**TECHNICAL INFORMATION PROVIDED IN
RESPONSE TO GULLI 4/19/19 PROTEST**

SMITH CANAL GATE PROJECT AGENDA NO. 11A

APRIL 26, 2019

3. Hydraulic impact of Gate on other levees

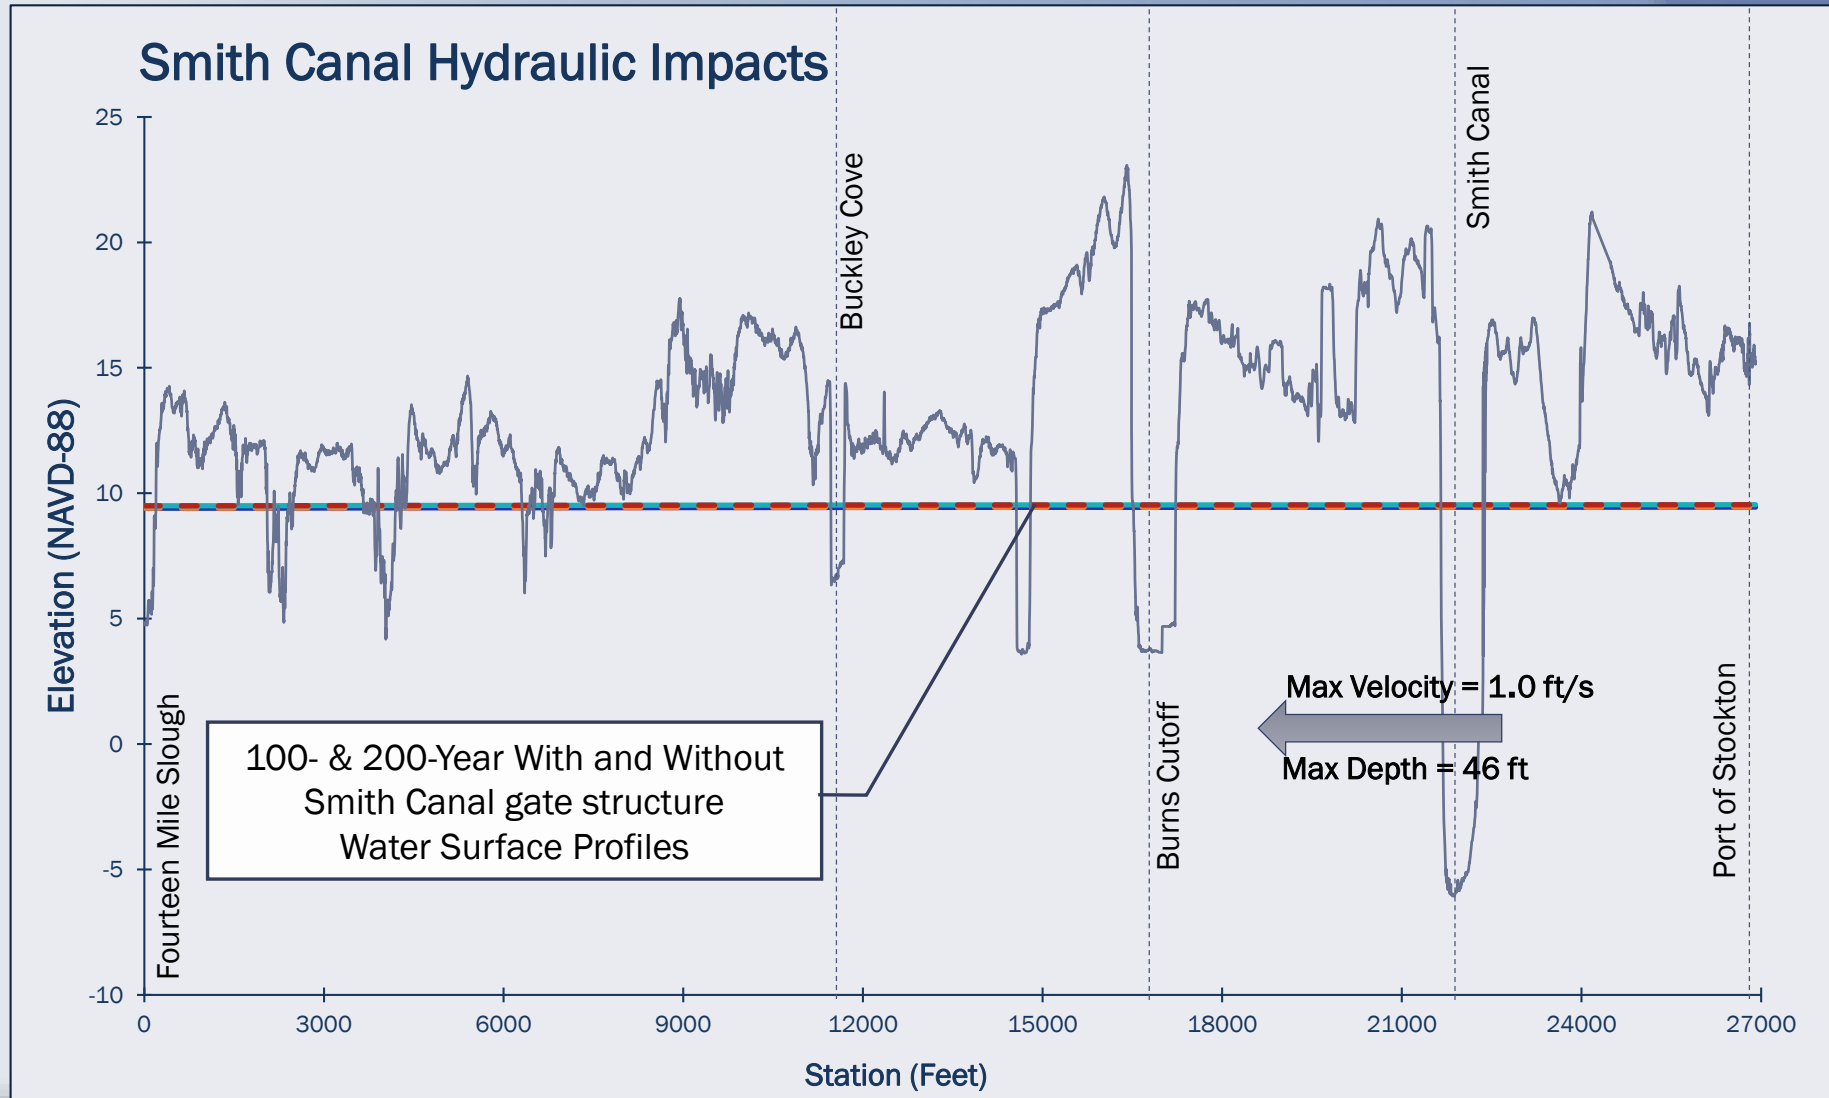
- ◎ Gate will be in the Delta Pool, essentially a very slow moving 61,000 acre lake with a nearly level water surface. In a high stage event, the gate will be closed, thus “walling off” the 85 acre Smith Canal and Atherton Cove. This "walled off" area is 0.14% of the wetted area of the Delta.
- ◎ FEMA water surface profiles are level, reflecting nearly still water. (see Gulli RFJN #160)
- ◎ PBI HEC-RAS modeling shows 0' stage rise due to a closed gate versus the without project condition in 100- and 200-yr floods (see next slide)
